Summary of Comments on SCSI Architecture Model - 4

Author: George Penokie Subject: Note Date: 11/20/2007 2:18:19 PM Comments: 001 - Brocade 017 - Emulex 205 - HPQ 001 - Network Appliance 021 - Quantum 096 - Western Digital Corporation -----341

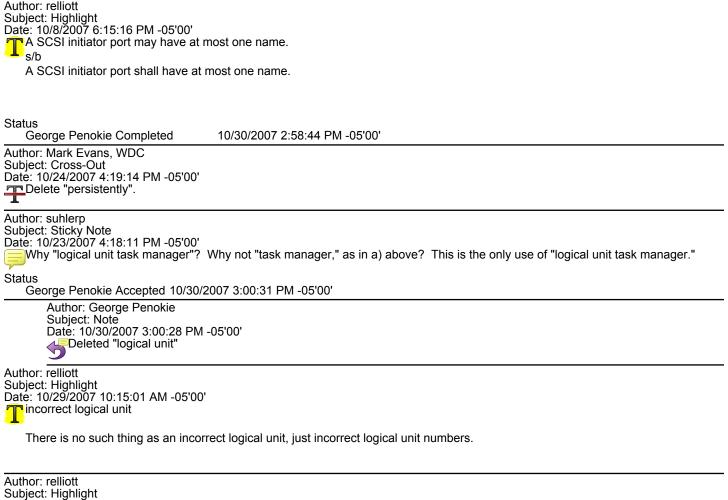
I think there shall be two or more SCSI devices and two or more SCSI ports, as shown in figure 16.

Subject: Highlight Date: 10/8/2007 5:54:20 PM -05'00' A Service Delivery Subsystem class s/b The Service Delivery Subsystem class

That's not correct. A SCSI device is allowed to contain both an initiator and a target. Also a SCSI port is allowed to contain an initiator port and a target port. So given that it's one or more SCSI devices and one or more SCSI ports. The instance diagram is only one example of what it could look like. The could be an instance diagram that showed only one SCSI device and one SCSI port but that would not be very interesting.

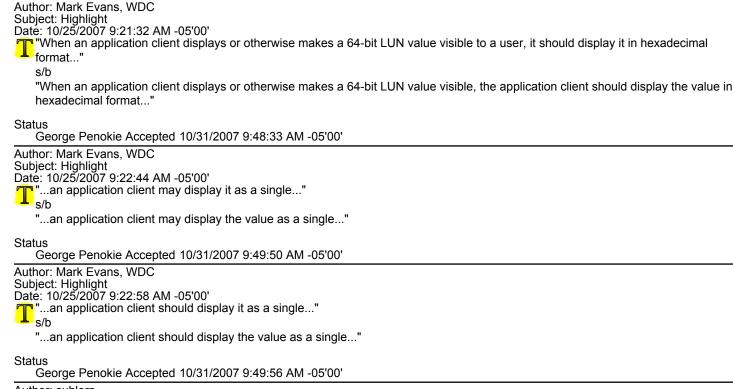
Author: Mark Evans, WDC Subject: Highlight Date: 10/29/2007 12:20:11 PM -05'00' "c) Data Transfer Terminated operation (see 5.4.3.4.3) to determines..."][s/b "c) Data Transfer Terminated operation (see 5.4.3.4.3) to determine..." Status George Penokie Accepted 10/30/2007 4:07:29 PM -05'00' Author: relliott Subject: Highlight Date: 10/8/2007 5:46:55 PM -05'00' Task class s/b Task class (see figure 22) Status George Penokie Accepted 10/30/2007 4:08:13 PM -05'00' Author: relliott Subject: Highlight Date: 10/27/2007 12:29:14 PM -05'00' (see 8.6) contains Delete the blue underline after the ")" and before "contains" Status George Penokie Accepted 10/30/2007 4:09:25 PM -05'00' Author: suhlerp Subject: Sticky Note Date: 10/23/2007 4:52:53 PM -05'00' SPC-4? Status George Penokie Accepted 10/30/2007 4:10:07 PM -05'00' Author: George Penokie Subject: Note Date: 10/30/2007 4:10:04 PM -05'00' Changed to SPC-4. Author: relliott Subject: Highlight Date: 10/29/2007 9:13:13 AM -05'00' SPC-3 s/b SPC-4 or delete this reference and just refer to 5.2 alone

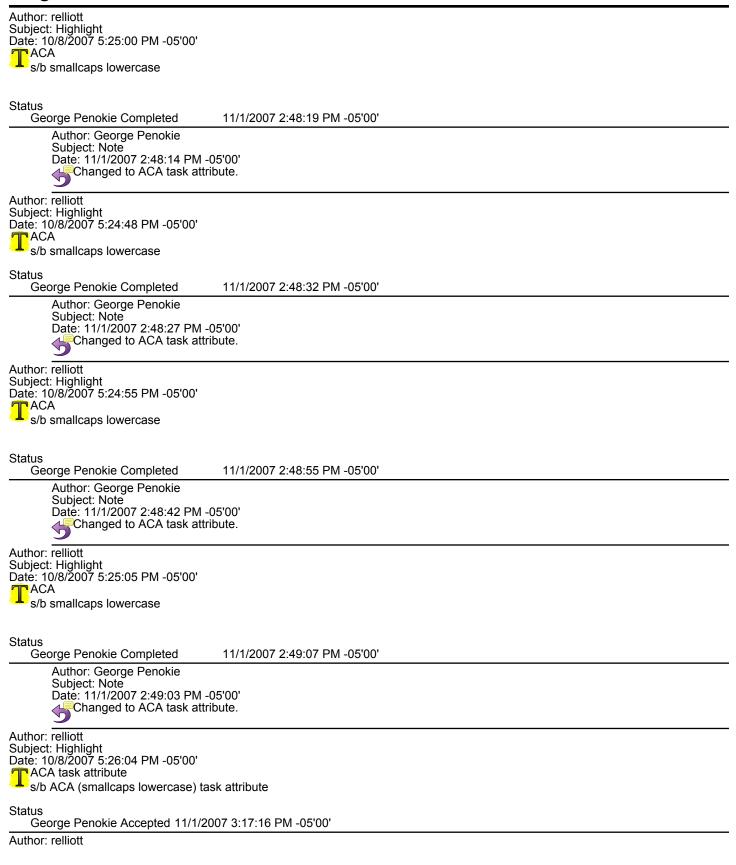
Subject: Highlight Date: 10/8/2007 5:25:39 PM -05'00' CACA task attribute s/b ACA (small caps lowercase)
